2 Type of change

Product Change Notification					PCN FMW-52 and FMAB case 09 redesign		
owner	creation date	release date	released by	change order no	rev	page	D10-032-874
segatro	04.01.2019	16.01.2019	romanogu	2016836	A	1 of 2

Old mechanical drawing	New mechanical drawing
<p>Case 09 with quick connect terminals class I</p>	<p>Case 09 with quick connect terminals class I</p>
<p>Case 09 with quick connect terminals class II</p>	<p>Case 09 with quick connect terminals class II</p>

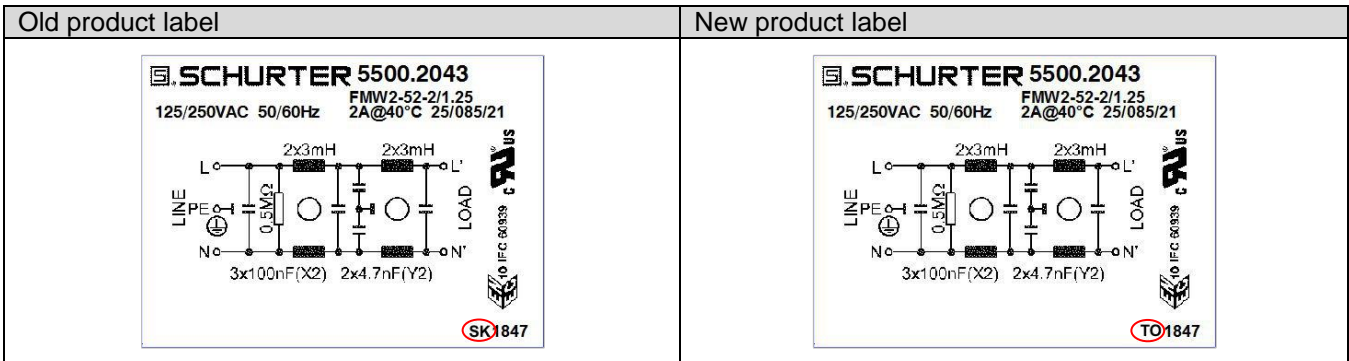
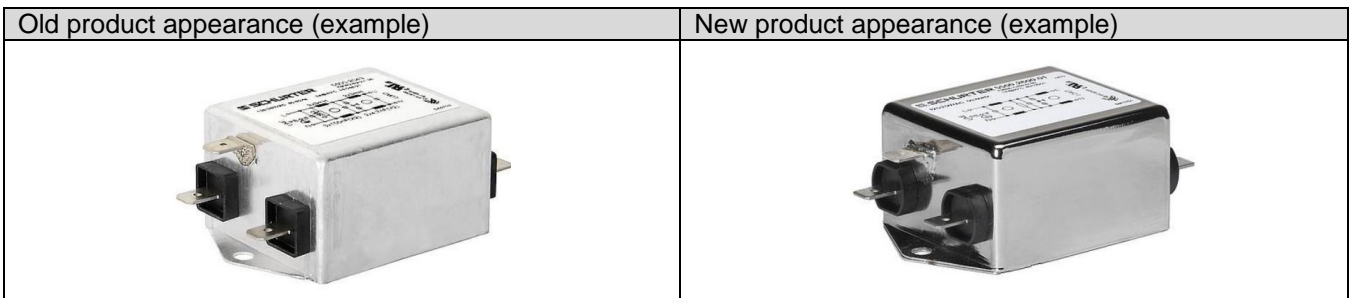
- Nickel plated case instead of aluminium case
- Production transfer from Slovakia (SK) to Romania (RO)

- Change of product appearance due to new nickel plated case instead of aluminium case and different shape of plastic part for quick connect terminals see photo below
- Change of factory code from SK to TO and origin from SK to RO on product and packaging labels, see below
- Different shape of plastic part for external quick connector terminals
- New cases are provided with a bottom cover
- Position of earth terminal
